Request for Additional Information No. 29, Revision 0

U. S. EPR Standard Design Certification

AREVA NP Inc.

Docket No. 52-020

Figure 15.4-44—Uncontrolled Control Bank Withdrawal from a Subcritical or Low Power Startup Condition - Primary Hot Leg Temperature

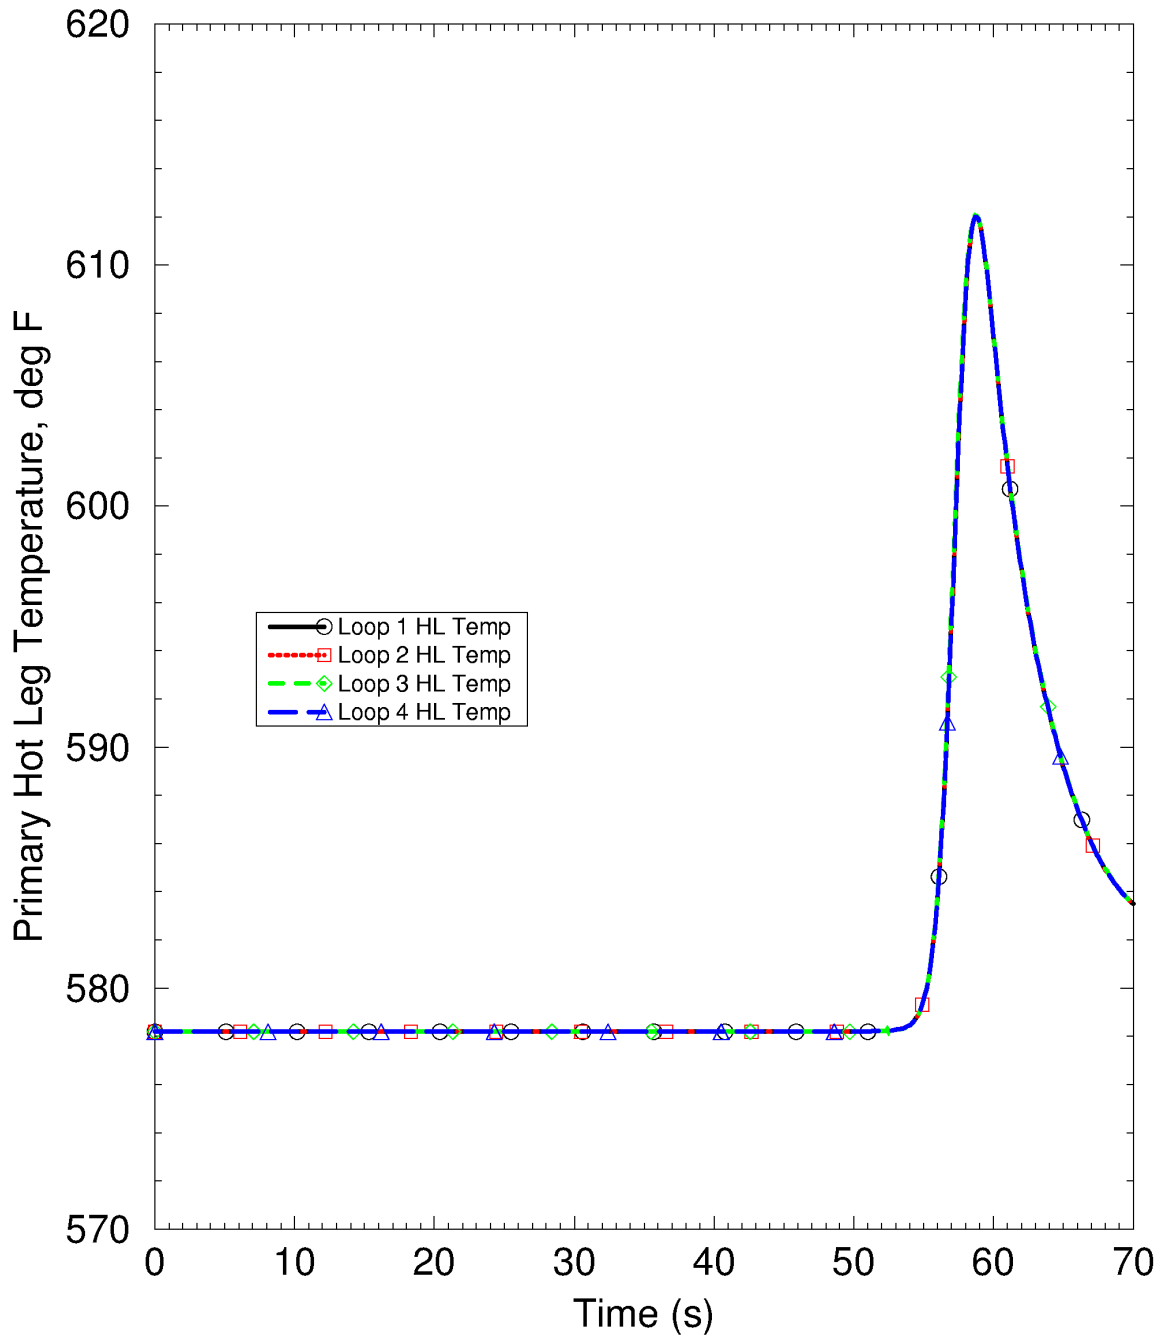
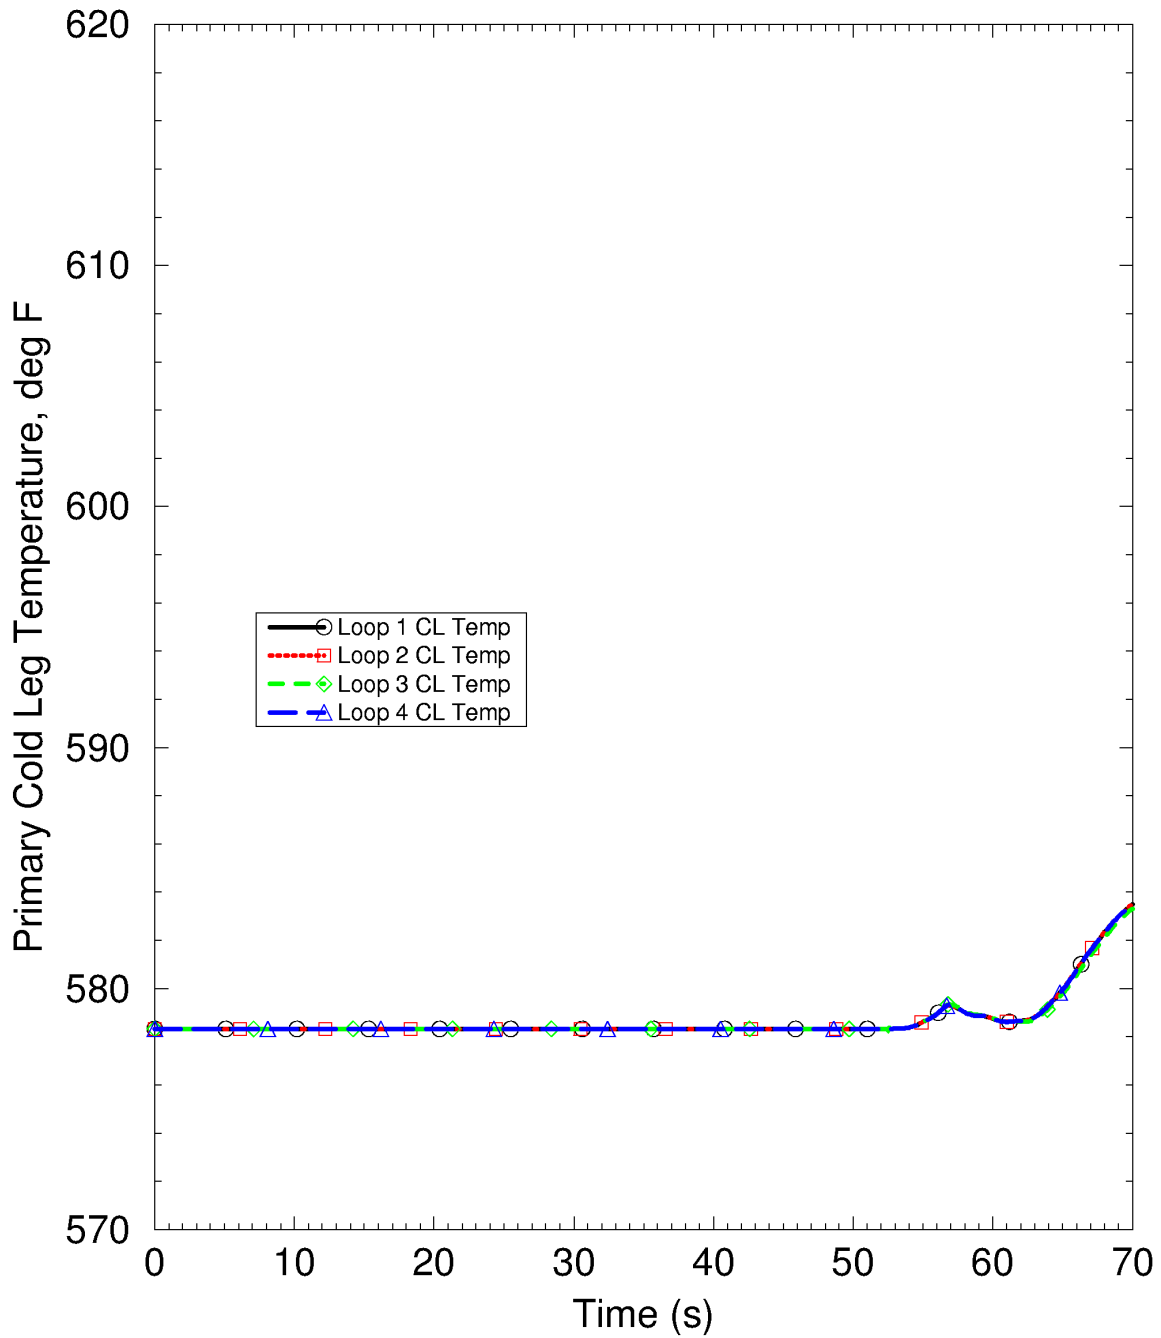
Please explain Figure 15.4-4—“Uncontrolled Control Bank Withdrawal from a Subcritical or Low Power Startup Condition - Primary System Temperature”. The figure shows the temperature excursion in the hot leg of loop 4 following reactor trip during coastdown of the RCPs. Explain the physical basis for the temperature excursion. Describe the S-RELAP model used in these calculations. Explain the consistency of these temperature predictions and the EPR non-LOCA vessel model shown in ANP-10263P-A, Rev 0, “Codes and Methods Applicability Report for the US EPR”.

Per discussion with the NRC staff during the May 2008 audit, this question was clarified to address the apparent difference in the temperature behavior of the four loops. To more clearly distinguish the hot leg and cold leg temperatures, U.S. EPR FSAR, Tier 2, Figure 15.4-4 is supported with two additional figures in the U.S. EPR FSAR, Tier 2, Section 15.4. Figure 15.4-44—Uncontrolled Control Bank Withdrawal from a Subcritical or Low Power Startup Condition - Primary Hot Leg Temperature shows the hot leg temperatures, and Figure 15.4-45—Uncontrolled Control Bank Withdrawal from a Subcritical or Low Power Startup Condition - Primary Cold Leg Temperature shows the cold leg temperatures. The figures show the coolant temperature behavior is nearly identical in the four loops.

U.S. EPR FSAR, Tier 2, Figure 15.4-44 and Figure 15.4-45 will be added as described in the response and indicated on the enclosed markup. U.S. EPR FSAR, Tier 2, Section 15.4.1.3 will be revised as indicated on the enclosed markup to incorporate the new figures.

Figure 15.4-46—Uncontrolled Control Bank Withdrawal from a Subcritical or Low Power Startup Condition - Normalized Minimum DNBR and FCM to SAFDL

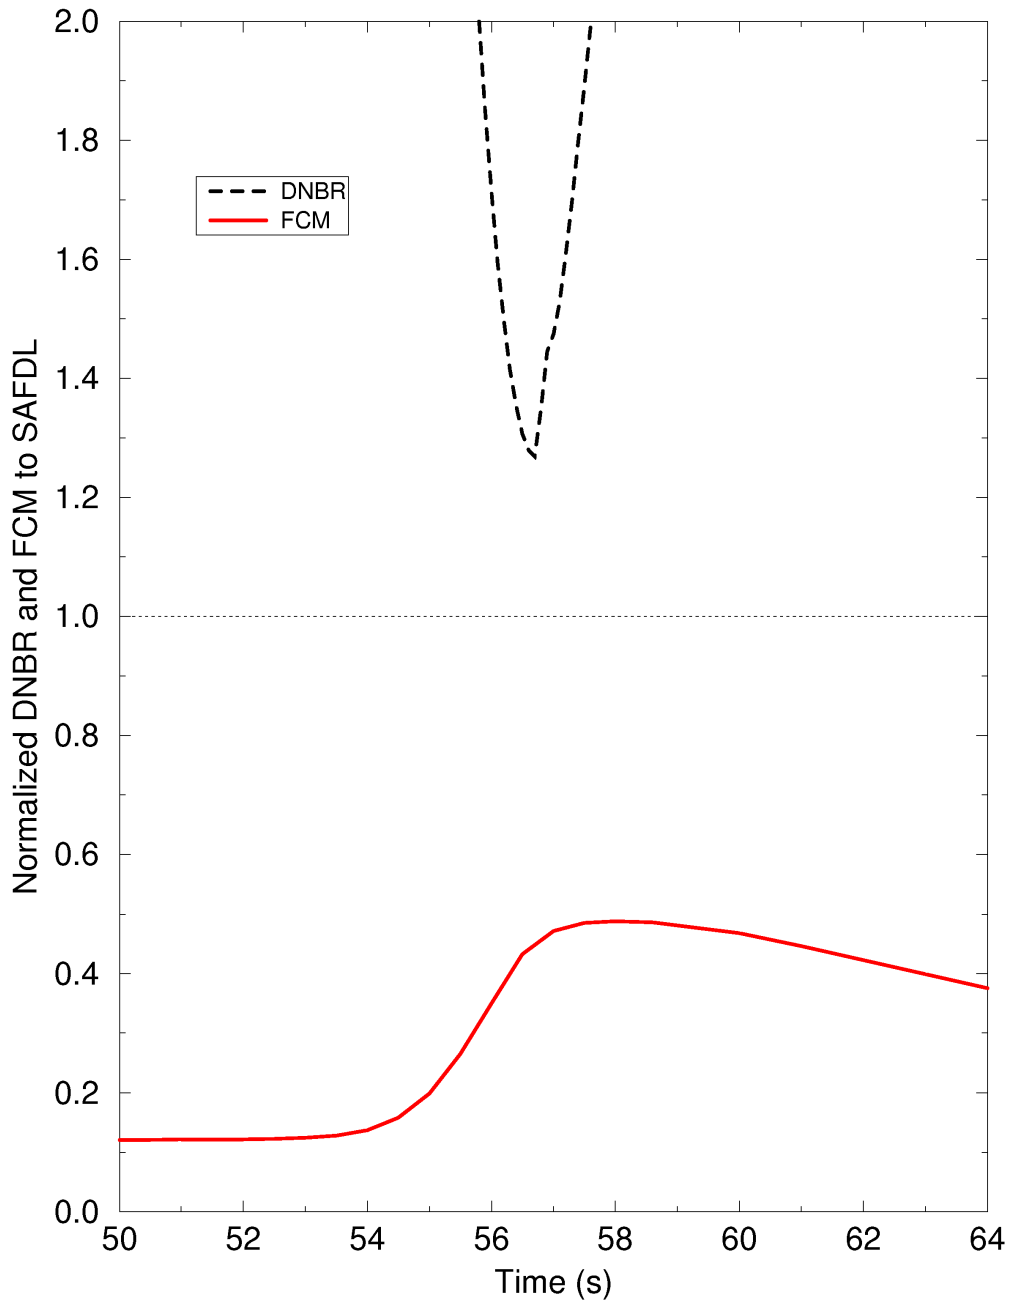
Please provide plots of DNBR and peak fuel centerline temperature as a function of time during this event to demonstrate that these limits are met.

A plot of the minimum departure from nucleate boiling ratio (DNBR) and peak fuel centerline temperature normalized to their respective SAFDLs (specified acceptable fuel design limits) is provided in the enclosed new U.S. EPR FSAR, Tier 2, Figure 15.4-46—Uncontrolled Control Bank Withdrawal from a Subcritical or Low Power Startup Condition - Normalized Minimum DNBR and FCM to SAFDL. Because this event is initiated from a low power condition where the incore monitoring system is inactive, a deterministic evaluation of DNBR and fuel centerline melt (FCM) is performed with the thermal-hydraulic code LYNXT. This is consistent with ANP-10287P, Revision 0, “Incore Trip Setpoint and Transient Methodology for the U.S. EPR Topical Report.” Additionally, a deterministic calculation of cladding strain for this event shows a maximum cladding strain of 0.80 percent (i.e., 80 percent of the one percent uniform cladding strain limit).

U.S. EPR FSAR, Tier 2, Figure 15.4-46 will be added as described in the response and indicated on the enclosed markup. U.S. EPR FSAR, Tier 2, Section 15.4.1.3 will be revised as described in the response and indicated on the enclosed markup to incorporate the new figure.

Figure 15.4-47—Startup of an Inactive Reactor Coolant Pump at an Incorrect Temperature - Normalized Minimum DNBR and Maximum LPD to SAFDL

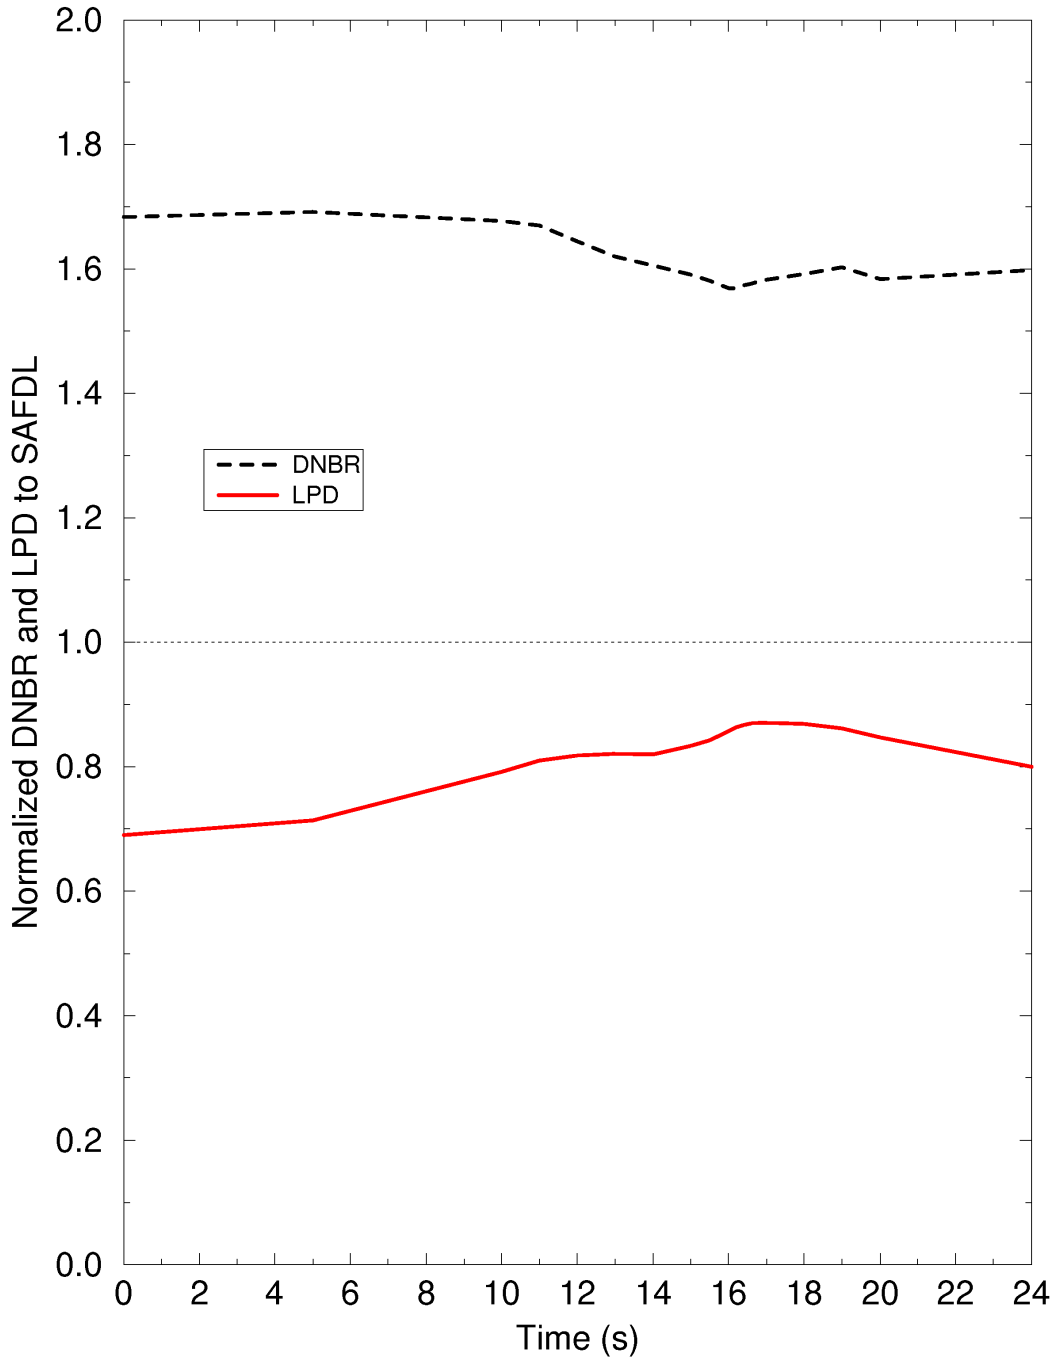
Provide the calculated DNBR as a function of time during the transient.

A plot of the minimum departure from nucleate boiling ratio (DNBR) and maximum linear power density (LPD) normalized to their respective specified acceptable fuel design limits (SAFDL) is shown on the enclosed markup as U.S. EPR FSAR, Tier 2, Figure 15.4-47—Startup of an Inactive Reactor Coolant Pump at an Incorrect Temperature - Normalized Minimum DNBR and Maximum LPD to SAFDL. The line indicated as “LPD” is the calculated LPD normalized to either the fuel centerline melt or cladding strain limits (whichever is more limiting), including applicable uncertainties.

U.S. EPR FSAR, Tier 2, Section 15.4.4.2 and Section 15.4.4.3 will be revised as described in the response and indicated on the enclosed markup. U.S. EPR FSAR, Tier 2, Figure 15.4-47 will be added as described in the response and indicated on the enclosed markup.

Figure 15.4-48—HFP Rod Ejection Accident Overpressurization Analysis - Primary Hot Leg Temperature

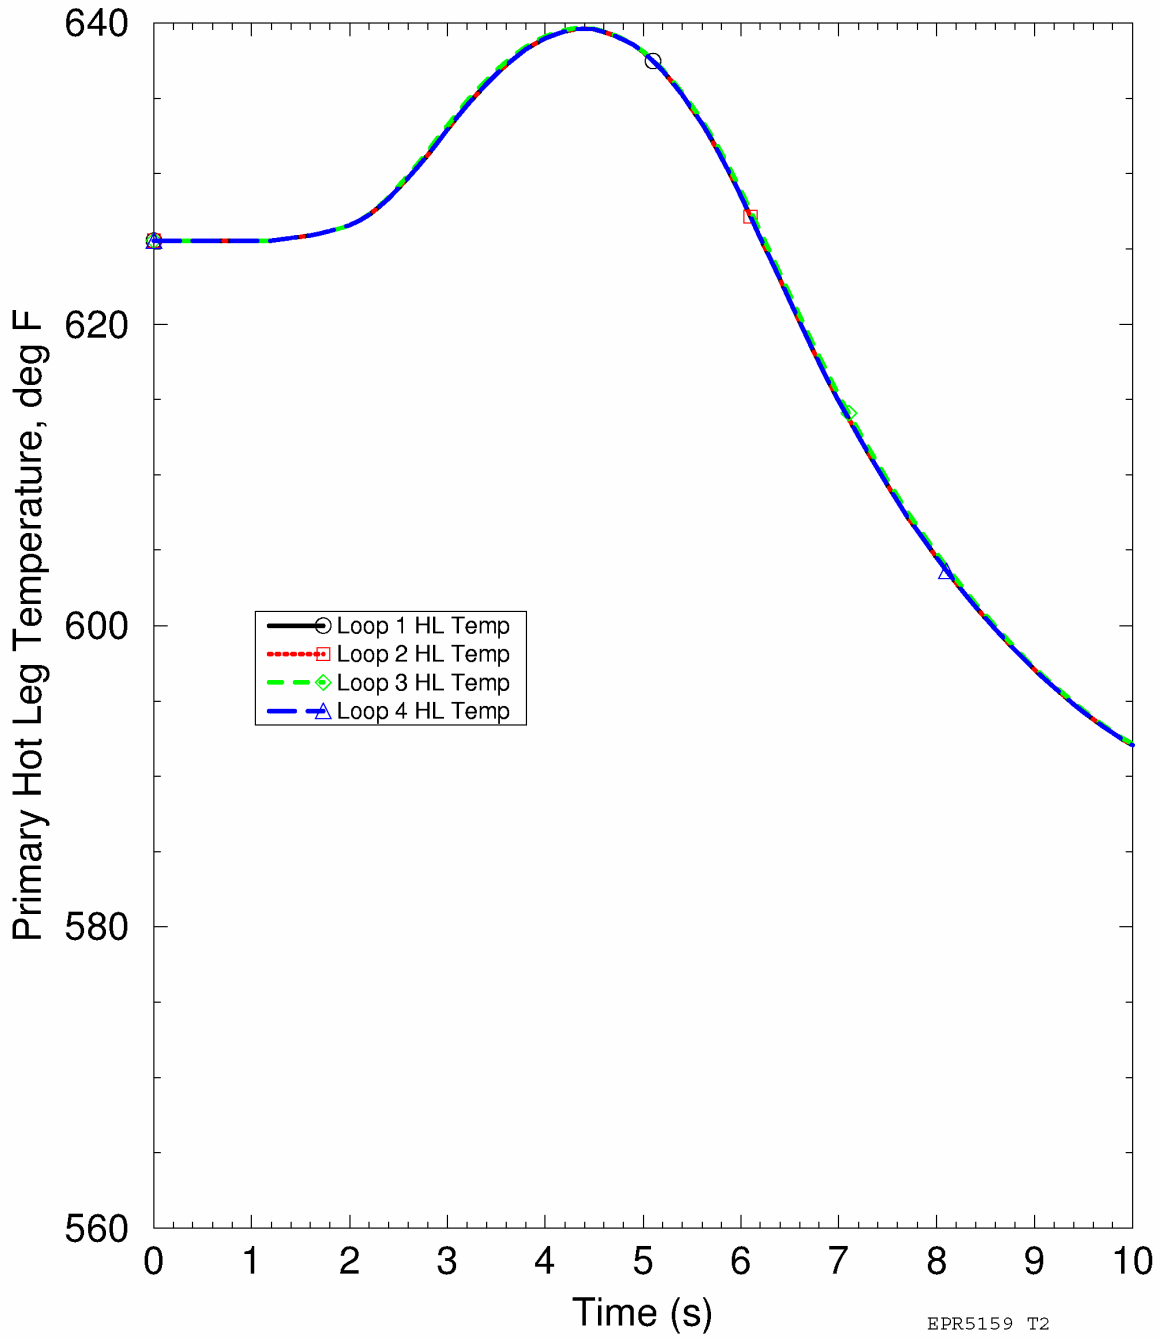
Explain the physical basis of the loop 4 temperature excursion shown in Figure 15.4-35—HFP Rod Ejection Accident Overpressurization Analysis –Primary System Temperature, Figure 15.4-39—60% NP Rod Ejection Accident Overpressurization Analysis – Primary System Temperature, and Figure 15.4-43—H2P Rod Ejection Accident Overpressurization Analysis – Primary System Temperature. Consider the time delays in the nuclear power, heat transfer from the fuel to the coolant, and fluid mixing in the reactor pressure vessel.

Per discussion with the NRC staff during the May 2008 audit, this question was clarified to address the apparent difference in the temperature behavior of the four loops. To more clearly distinguish the hot leg and cold leg temperatures in U.S. EPR FSAR, Tier 2, Figure 15.4-35, Figure 15.4 39, and Figure 15.4-43 are supported with six additional figures in U.S. EPR FSAR, Tier 2, Section 15.4. Three figures show the hot leg temperatures, while the other three show the cold leg temperatures.

U.S. EPR FSAR, Tier 2, Figure 15.4-48, Figure 15.4-49, Figure 15.4-50, Figure 15.4-51, Figure 15.4-52, and Figure 15.4-53 will be added as described in the response and indicated on the enclosed markup. U.S. EPR FSAR, Tier 2, Section 15.4.8.3.2 will be revised as indicated on the enclosed markup to incorporate the new figures.
